MEMORANDUM

TO:	Planning and Zoning Commission
CC:	Andrew Wheeler, DG Group Architecture
FROM:	Joseph Dodson, Current Associate Planner
RE:	Lennon Pointe Community AZ, PP, CUP (H-2021-0071)

Lennon Pointe Community AZ, PP, CUP (H-2021-0071) was heard by Planning and Zoning Commission on December 2, 2021. At that hearing the Commission continued the project to the January 20, 2022 hearing date for the following reasons outlined in their motion: create a better solution to the transition between the proposed multi-family building and the neighborhood to the east; modify the attached units on the east side of the site to be front-loaded; revise the plat to match any changes to the overall conceptual site plan.

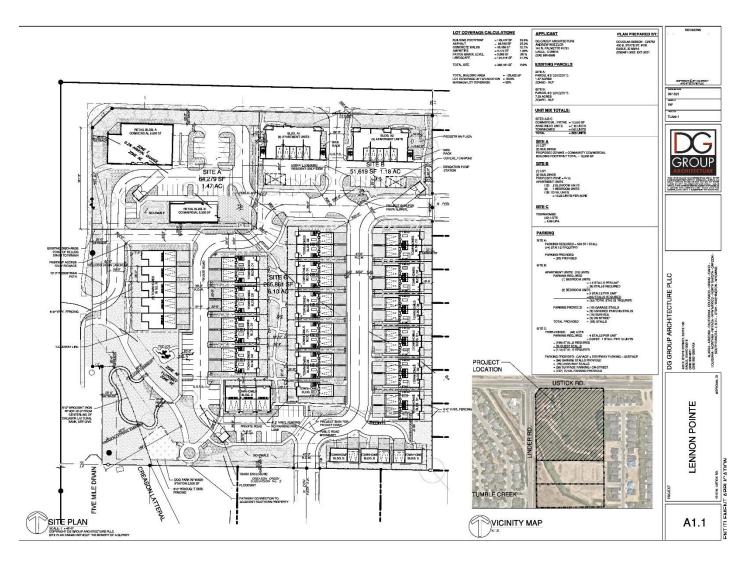
- Applicant added a segment of 10' multi-use pathway within the required landscape buffer along Linder Road.
- The Applicant also removed one unit from the 6-unit townhome building to move it out of the floodway and include a new drive aisle connection on the north end of this building. This new drive aisle offers additional separation between the commercial lot and the residential building but is not a required connection. Staff understands the benefit of this connection but could also envision additional open space in this area in lieu of more asphalt. Staff is recommending an additional condition of approval relating to this connection should Commission determine it should remain to ensure perpetual cross access.

- Add Provision <u>If cross-access is proposed between the commercial lot and the 5-unit</u> townhomes, the Applicant shall submit a recorded cross-access agreement to the Planning <u>Division at the time of Final Plat Signature to ensure perpetual cross-access between the</u> private street in the residential portion of the project and the commercial lot.

A. Revised Site Plan

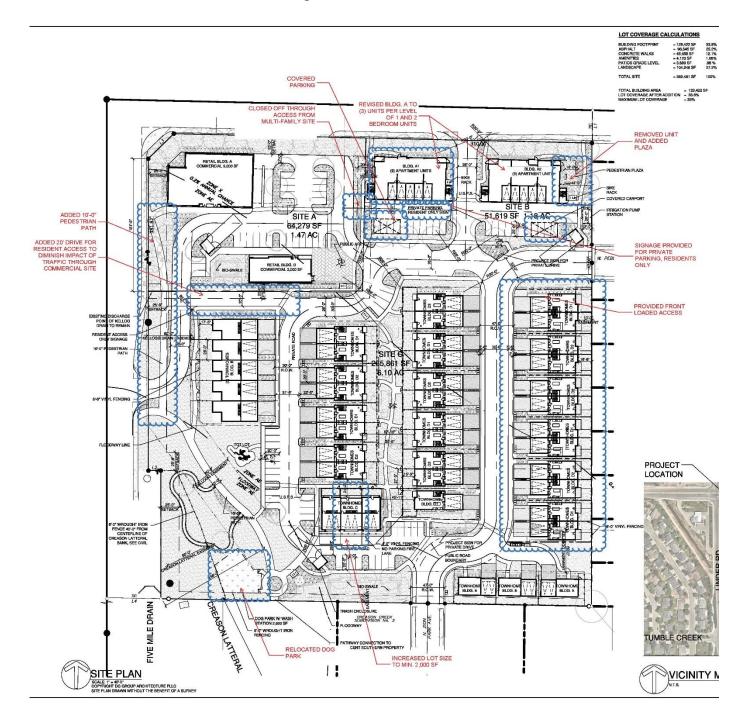
• **Reduction in height and size of apartment buildings** – the Applicant has revised the proposed apartment buildings along Ustick to be 3-story buildings instead of 4-stories. This has resulted in a slight height reduction of the buildings (37' at its highest point of the sloped roof) and an overall reduction of building massing. In addition, the Applicant removed the easternmost end-unit altogether which has resulted in further separation

from the existing single-family home to the east. According to the revised site plan, the proposed building is at least 44' from the east property line.

- By removing the apartment end-unit, the Applicant has now proposed an additional plaza area with pedestrian access to the sidewalk along Ustick.
- Applicant removed the cross-access point between the multi-family drive aisle and the commercial property to the west in order to reduce any cut-through traffic.

- Applicant converted the attached units along the east boundary to be front-loaded (facing west) and removed the walking path along the east boundary per Staff and Commission comments.

- Applicant moved the location of the proposed dog park as discussed at the hearing. It is now located within the larger open space lot in the southwest corner of the site.

- Applicant revised the lot sizes of the 3-unit townhome unit near the southwest corner of the site to meet the minimum lot size requirements in accord with Staff's condition of approval.
